1 Products affected

2 Type of change

Product Change Notification					PCN USF 1206 Change of electrical rating		
owner	creation date	release date	released by	change order	rev	page	
hotiar	10.12.2024	10.12.2024	gallatfa		A	1 of 2	D10-088-313

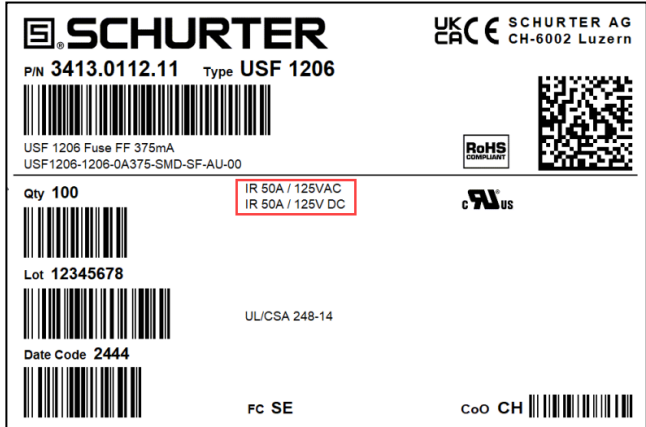
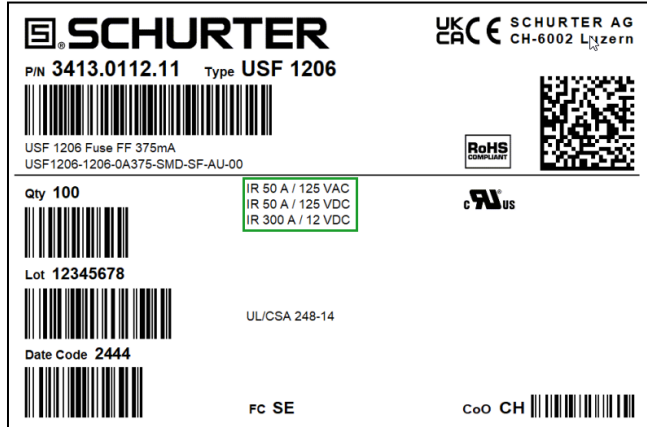
Current label	New label
 Current label details: SCHURTER, P/N 3413.0112.11, Type USF 1206, USF 1206 Fuse FF 375mA, USF1206-1206-0A375-SMD-SF-AU-00, Qty 100, Lot 12345678, Date Code 2444, UL/CSA 248-14, FC SE, CoO CH.	 New label details: SCHURTER, P/N 3413.0112.11, Type USF 1206, USF 1206 Fuse FF 375mA, USF1206-1206-0A375-SMD-SF-AU-00, Qty 100, Lot 12345678, Date Code 2444, UL/CSA 248-14, FC SE, CoO CH.
Current breaking capacity (BC) on data sheet	New breaking capacity (BC) on data sheet
Rated current 0.375 A and 0.5 A UL: 50 A @ 125 VAC/DC Rated current 0.75 A to 4 A UL: 50 A @ 32 VAC / 50 A @ 63 VDC	Rated current 0.375 A and 0.5 A UL: 50 A @ 125 VAC/DC / 300A @ 12 VDC $\tau = 0.2\text{ms}$ Rated current 0.75 A to 4 A UL: 50 A @ 32 VAC / 50 A @ 63 VDC 300 A @ 12 VDC $\tau = 0.2\text{ms}$

| ☒ Label | No action required. New breaking capacity rating |
